RE: Water Licence 2AM-MRY1325 September 2021 Inspection – Follow Up

2021-QIK-JKM012 2AM-MRY1325 Inspection Report

Table 1 – Baffinland Responses to CIRNAC 2021 September Inspection Report

Photo 16

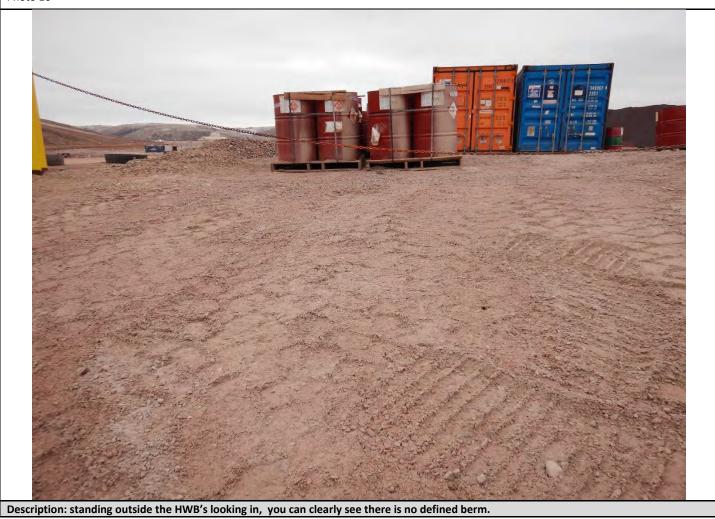
5) HWB 03 and 04- the is no defined berm where waste is being stored it appears if a spill did occur the waste would flow outside of this facility. See photo 16 for a picture of this facility.

5)	HWB 03 and 04	There is no defined berm where waste is being stored it appears as if a spill did occur the waste would flow outside of this facility. See photo 16 for a picture of this facility. The licensee is to ensure the following waste/water management structures are operating as intended and consistent with the design in the plans approved by the Nunavut Water Board; Ore stockpile ditches and gradient, Crusher pad ditches, MP-07 ditches, Western Globe Fuel Module, HWB 03, HWB 04.	Baffinland will regrade the area at the entrance of twin-cell HWB-3/HWB-4 prior to freshet 2022 to re-establish the gradient normally present within the cells. Routine inspections of HWB-3/ HWB-4 are completed regularly as part of the inspections of structures designed to contain, withhold, divert or retain waters or wastes during periods of flow; conducted in accordance with Part E Item 11 of the Water Licence.
